From: Clare Spiller
Sent: 25 October 2022 11:05
To: James Gilfillan
Cc: Simon Mcfarlane - AJC Group; Giles Moir
Subject: Orchard Gate, Dibden Purlieu
Attachments: FW: 5577: Dibden Purlieu - Detail Application

Orchard Gate, Noads Way, Dibden Purlieu
Planning Application 22/10813
HCC Reference: 046924

TITLE
Access Proposals

DRAWN BY ARM	DESIGN BY ITR	CHK BY ITR
DATE 27/04/21	DRAWING No. 5577 / 001	
SCALE 1:500 @ A2	REV No. E

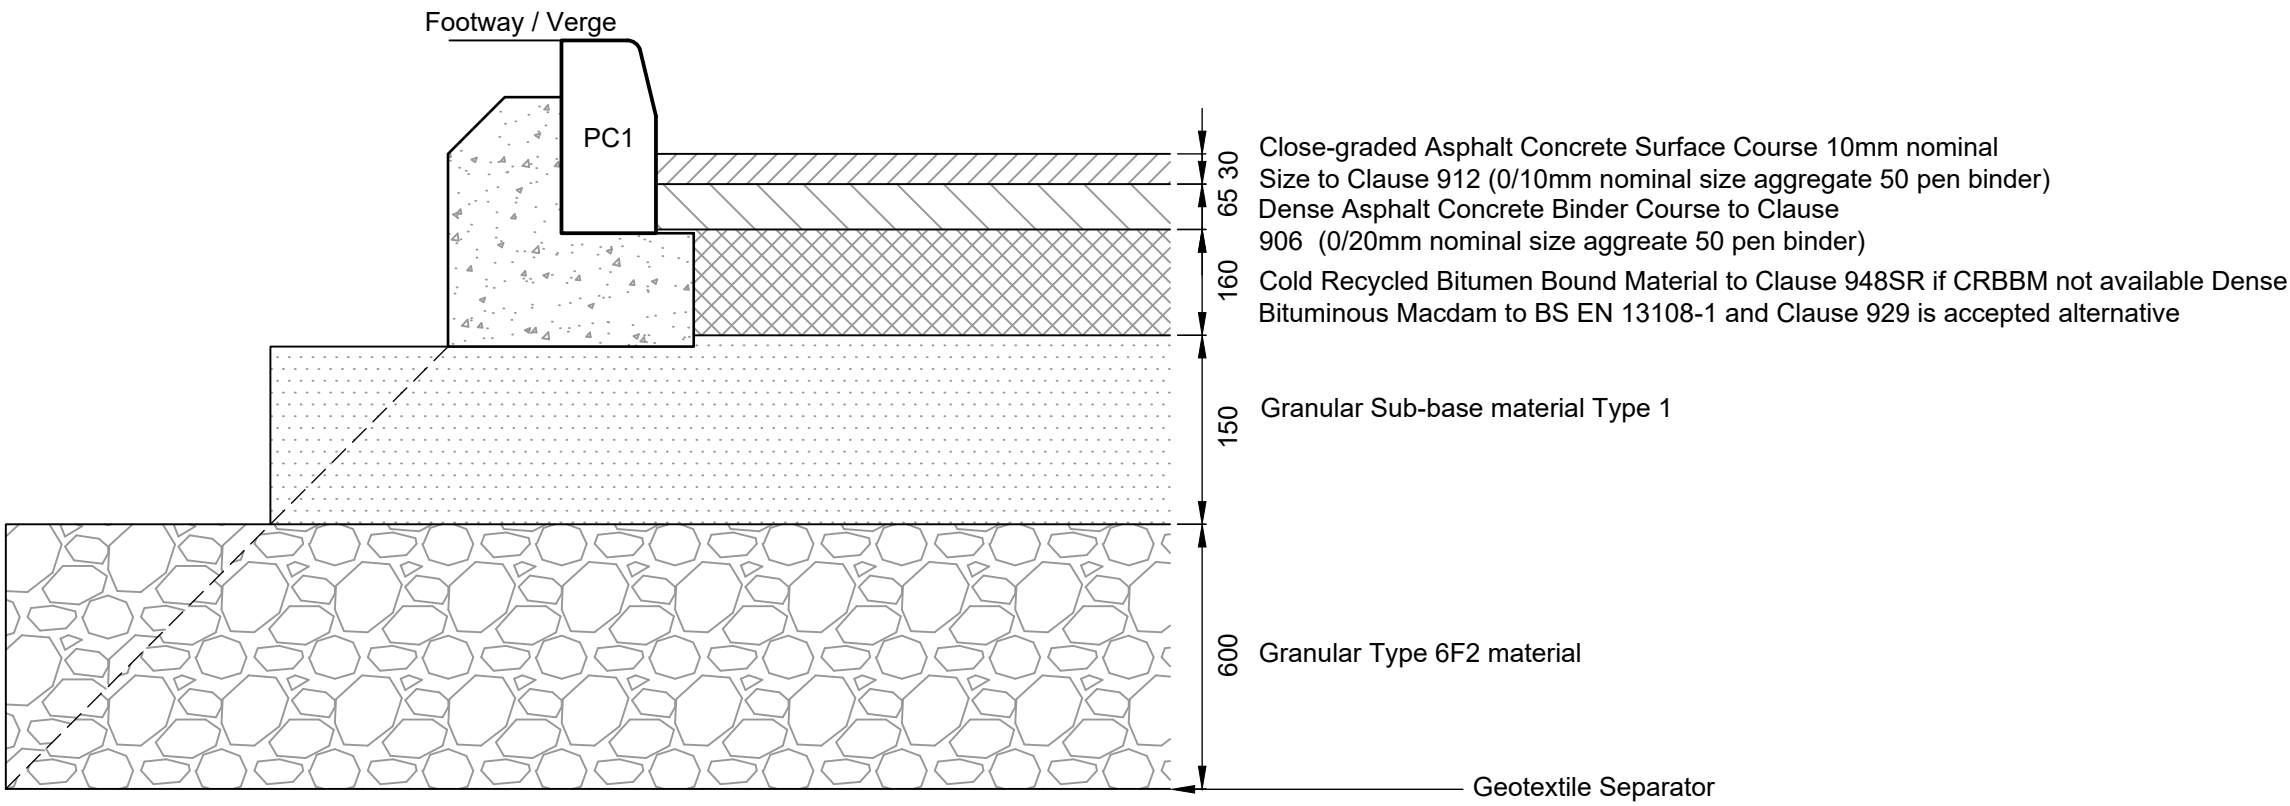
The plan 5577/001 Rev. D illustrates the visibility at the access of 2.4m x 43m in each direction, which was prepared **before** the speed surveys were undertaken and submitted within the Addendum Transport Statement. The speed survey was undertaken between 15th and 21st July 2022 as stated, and recorded 85th percentile speeds of:

The splays have been calculated as being 41.4m and 40.7m correctly. The period of the survey was dry and therefore there is no need to adjust the speeds.

The stopping sight distance calculated within TG3 of the Council's guidance was produced for the 'y' dimensions. However, the calculations add a distance of 2.4m to the 'y' distance for bonnet length. Such a requirement is not in accordance with MfS. The bonnet length should be added for the stopping sight distance (SSD), and I refer to Section 7.5 of MfS. Such a requirement is for vehicles travelling along the road and not stationary at the T-junction or access.

Section 7.7 of MfS refers to the 'y' dimension which is the distance a vehicle wishing to exit a junction or access which is required to see oncoming traffic. There is no requirement to add 2.4m to such a distance.

The vehicle travelling along the road (SSD) requires the extra 2.4m bonnet length, however, this visibility is taken at least 1.5m from the kerbside edge for the vehicle travelling along the major road and should not be applied to the 'y' dimension.

Paragraph 7.7.10 clearly states that the 'y' distance should be based on values for SSD, it does not say that the 'y' distance should be based on the values for SSD plus 2.4m bonnet length. That requirement clearly is for the traffic travelling along the major road, reference paragraph 7.6.4. This mis-reading of MfS is a common mistake.

However, notwithstanding the above point, I attach the revised access drawing illustrating the 'y' dimension of 46m in each direction rather than the required 43m, which is commensurate with the recorded speeds. (See plan 5577/001 Rev. E attached.)
